Redesigned Bull Gear

for the Stolle 6-Color Rutherford Decorator

Technical Update 1110-1

*Redesigned bull gear for the
6-Color Rutherford Decorator*

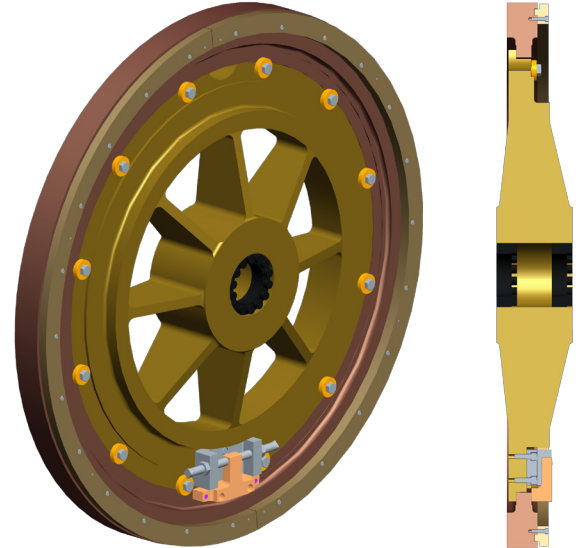
Stolle has redesigned the bull gear for a 6-color Rutherford Decorator to reduce vibration, improve registration and print quality. The existing one-piece bull gear has been replaced by a two-piece hub and gear design. The size of the hub has been increased to reduce the vibration in the system and reduce registration variation caused by this vibration.

The new design also includes an improved timing mechanism. The position of the gear can now be adjusted with respect to the hub, which will allow the customer to adjust the timing of the gear without loosening the hub on the main shaft. The new two piece design will also allow for faster replacement of the gear since the hub will not need to be removed.
